Access Compliance Report Public Rights-of-Way (Curb Ramps)

Main Street: CHAPMAN_AVE Cross Street: CHAPMAN_AVE Location: S

ADA ID: RPRK210928154206 Ramp Type: Type 1 - Perpendicular Initial Pass/Fail: Fail Overall Compliance: No Severity Score: 30

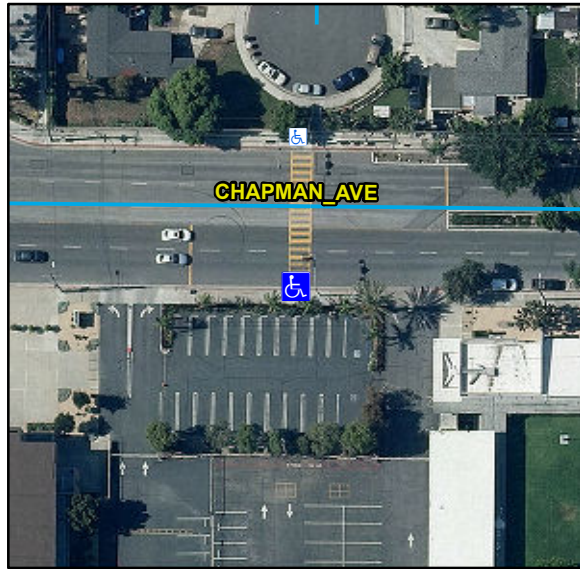
Compliance	Description	Data	Compliance	Description	Data
N/A	Ramp Length (in)	96	N/A	Flare Type LT	
Yes	Ramp Width (in)	48			N/A
No	Ramp Run Slope (%)	15	N/A	Flare Slope LT (%)	N/A
Yes	Ramp Cross Slope (%)	1	N/A	Flare Traversable LT	N/A
N/A	Landing Present	N/A	N/A	Flare Type RT	
N/A	Landing Length (in)	N/A			N/A
N/A	Landing Width (in)	N/A	N/A	Flare Slope RT (%)	N/A
N/A	Landing Run Slope (%)	N/A	N/A	Flare Traversable RT	N/A
N/A	Landing Cross Slope (%)	N/A	N/A	DWS Provided	N/A
N/A	Landing Movement Obstructed?	N/A	N/A	DWS Contrast	N/A
	Landing Movement Type	N/A	N/A	DWS Length (in)	N/A
N/A	Landing Shared	N/A	N/A	DWS Full Width	N/A
N/A	Clear Space	N/A	N/A	DWS Offset Left (in)	N/A
N/A	Clear Space To Crosswalk (in)	N/A	N/A	DWS Offset Right (in)	N/A
N/A	Marked Crosswalk 1	Yes	N/A	Marked Crosswalk 2	N/A
	Crossing 1 Direction	N		Crossing 2 Direction	N/A
	Marked Crosswalk 1 Width (in)	132		Marked Crosswalk 2 Width (in)	N/A

N/A	Ramp Inside Crosswalk 1	Yes	Yes	Ramp Inside Crosswalk 2	N/A
	Crossing 1 Slope (%)	2.3		Crossing 2 Slope (%)	N/A
	Crossing 1 Cross Slope (%)	1.7		Crossing 2 Cross Slope (%)	N/A
N/A	Gutter Ponding	N/A	No	Curb Slope	13.2
No	Gutter Lip Height (in)	0.5		Road Run Slope (%)	N/A
N/A	Gutter Run Slope (%)	N/A		Road Cross Slope (%)	N/A
N/A	Gutter Cross Slope (%)	N/A			
Yes	Overall Surface Condition: Acceptable		No	Perp Joint Present	No
	Cross Gutter Present?	No		Spandrel Present?	No
	Replace Cross Gutter?	N/A		Replace Spandrel?	N/A

Remove & Replace Entire Ramp.
